Service Bulletin

Bulletin No.: 10-06-01-008L

Subject: Engine Oil Consumption on Aluminum Block/Iron Block Engines with Active Fuel Management (AFM) (Install AFM Oil Deflector and Clean Carbon from Cylinder and/or Install Updated Valve Cover)

2740641

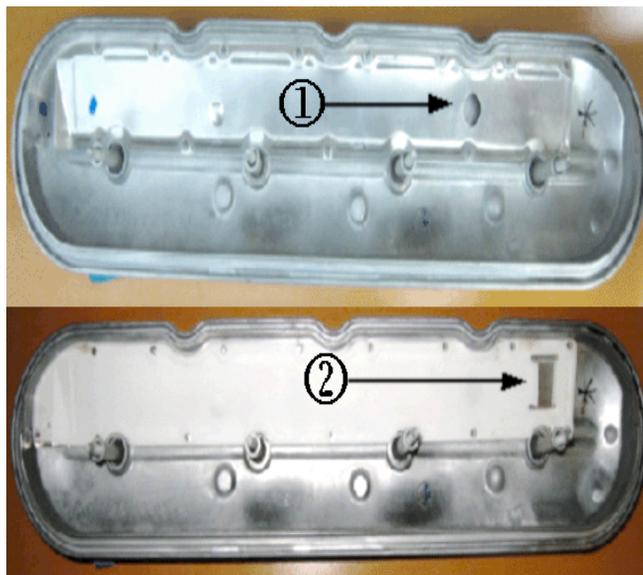
Aluminum or Cast Iron Block - Oil in Intake Manifold - Install Updated Valve Cover on All Models Built Prior to February 1, 2011

- 1) Old Design
- 2) New Design

PCV pullover or an overactive lifter can cause oil to be pulled through the PCV system even at low vehicle mileage. A correctly functioning PCV system will only leave a film of oil in the intake manifold. Inspect the intake manifold to see if there is any oil puddling in the bottom. If there is you will need to replace the left valve cover. Two new left rocker arm covers have been released for trucks and vans. Technicians should replace the left rocker arm cover with GM P/N 12570427 for 2007-2008 or GM P/N 12642655 for 2009-2011. Refer to the Parts Information below for the Camaro. This rocker arm cover has a relocated PCV drain hole that prevents oil from entering the intake manifold. Refer to Valve Rocker Arm Cover Replacement - Left Side in SI.

Note: These rocker covers are for specific years. The PCV orifice is different for each. The correct cover must be used or an SES light may set.

2474205

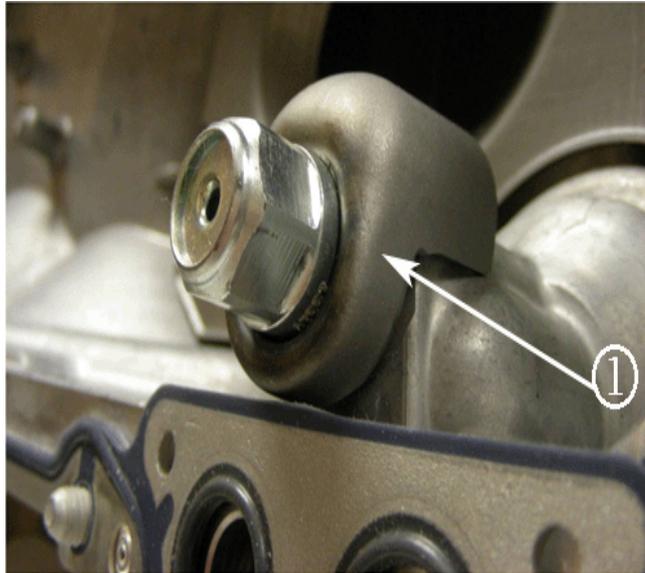
4. Remove the AFM valve (1).
